E9821A-02

S E R V I C E N O T E

E9821A Digital Signal Processor for E3238S systems (Option 101 - G4 processor card with extended RAM)

View showing the caps in the thermal pad cutouts, with the metal part and upper pads removed:

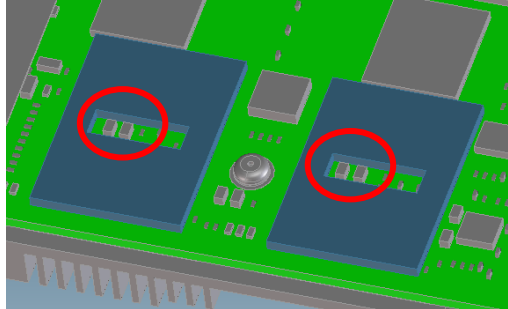
A short may occur between capacitors on top of Option 101 Processor Card and Heat Spreader. When compressed, one or more of the four tall caps under the heat spreader—located inside the thermal pad cutout—may short to the metal part of the heat spreader.

The solution is to replace the heat spreader for each option 101 installed on the E9821A with one that will not allow the capacitors to make electrical contact with the metal heat spreader.

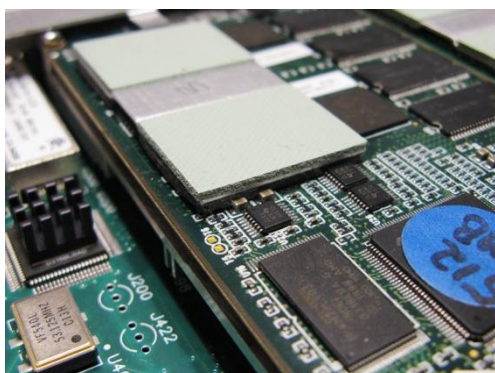
2. **Remove old heat spreaders:** Use a small plastic prying tool to gently remove the heat spreader

3. **Install new heat spreader:** Gently press the new heat spreader in place. There are no screws that hold the heat spreader on the board or guides for placement of the heat spreader. Simply match the placement of the heat spreader with the pictures below and gently press it in to place. The top cover will hold the heat spreader in place.
